Addendum to
Planning
Statement

Nant Llesg Surface Mine

Addendum to Planning Statement

Applicant's Response to Post-Application Representations

Figure PSA13.1 Location of 3 m barrier at Halfway House

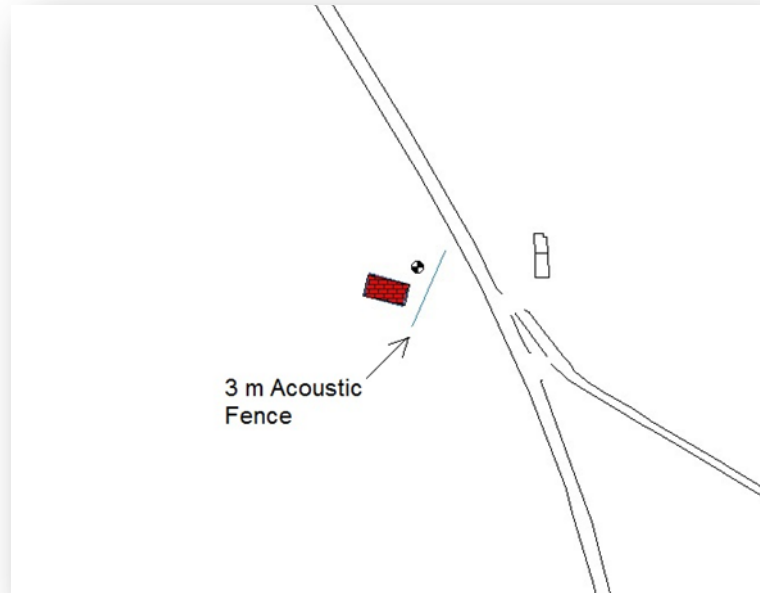
- 13.5 A 3 m high noise barrier was proposed within the planning application close to the south eastern boundary of Halfway House. The calculated noise levels (in dB LAeq) for each disposition with and without the 3 m barrier are shown in Table PSA13.1 together with reductions in noise (in dB) at the house during the various phases of the proposed development. The location of the barrier included in the IMMI model is shown in Figure PSA13.1 below. The 3 m barrier would have been of a similar construction to that of the 2 m noise fence shown in Figures PSA13.1 and PSA13.2 and Drawing MA/NL/PA/58.

Figure PSA13.2 Location of 2 m barrier at Halfway House and 3m bund at edge of working area for Disposition 1B

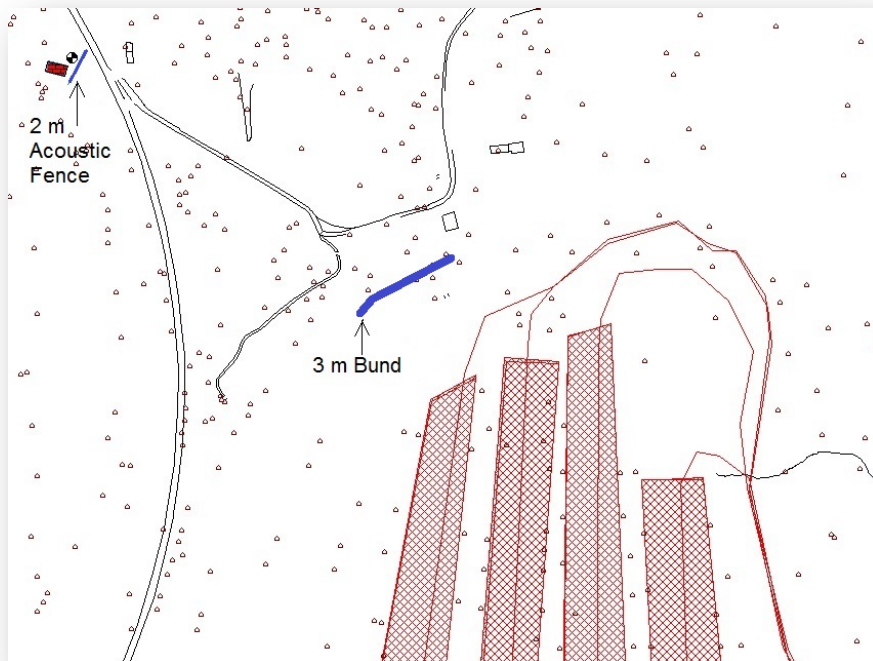
- 13.7 Since the submission of the Nant Llesg Planning Application and following questions raised during consultation further work has been carried out to investigate if it would be possible to reduce the height of the proposed 3 m barrier at Halfway House and still achieve the proposed noise limits. To achieve this, given the topography of the land between the house and the workings, means that a lower screen at the house would need to be used in conjunction with an additional screening bund at the edge of the working area. This offers an alternative solution that would be as effective as the use of the 3 m screen proposed in the ES. The location of the reduced barrier and the top of the screening bund at the edge of the excavation area is represented in Figure PSA13.2. The position and profile of the proposed screening bund can be seen on Drawing MA/NL/PA/057. The proposed noise fence, reduced to a height of 2 m is shown on Drawing MA/NL/PA/058 'Typical Detail of Acoustic Noise Fence' and the typical appearance is shown at Figures ESA13.1 and ESA13.2 of the Second Addendum to the ES.

- 13.8 The use of the barrier and screening bund will reduce the noise at Halfway House as shown below for the three dispositions where an excess was predicted in the absence of any screening:

Figure PSA18.1 All emergency respiratory disease admissions 2001/2 to 2011/12, per 100,000 population, age-standardised

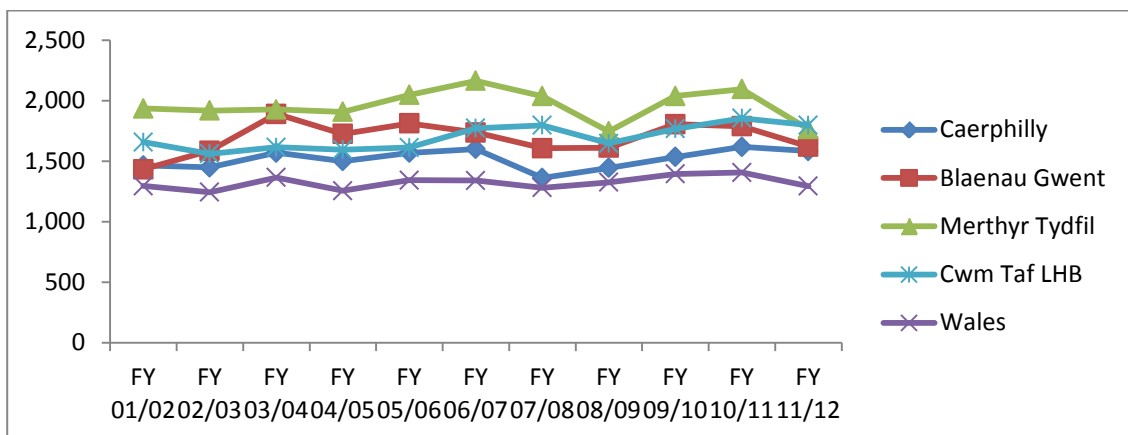
18.14 Figure 3.10 of the HIA also provided trend data for total respiratory hospital admissions from 2001 to 2010. Since then, and as shown below in Figure PSA18.1, the independent and routinely collected hospital admission data has been updated to include 2011/12.

- 18.15 As shown above in figure PSA18.1, while variation is expected for health endpoints with multiple risk factors, the total respiratory hospital admission trend since 2001 remains relatively consistent, with Caerphilly and Blaenau Gwent being in keeping with the Cwm Taf Local Health Board (LHB) rate for the region.

Figure PSA18.2 Asthma and COPD emergency admissions 2001/2 to 2011/12, per 100,000 population, age-standardised

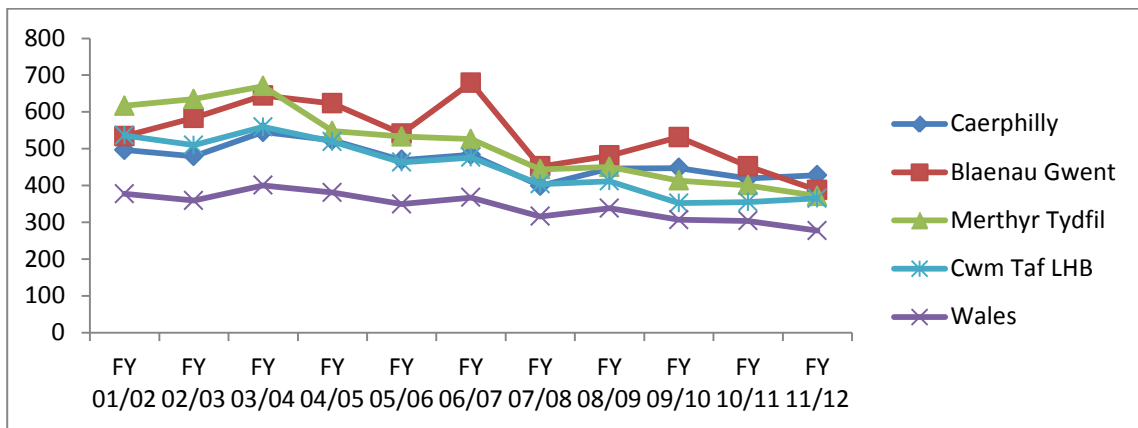
- 18.17 When further interrogating the hospital admissions data to consider asthma and COPD with potential causal mechanisms that could credibly be associated with current operations, it is the case that rates have been on the decline since 2001; are the lowest they have been for over a decade; that Blaenau Gwent, Merthyr Tydfil and the Cwm Taf LHB currently have rates lower than Caerphilly, and the gap from the national rate is closing.
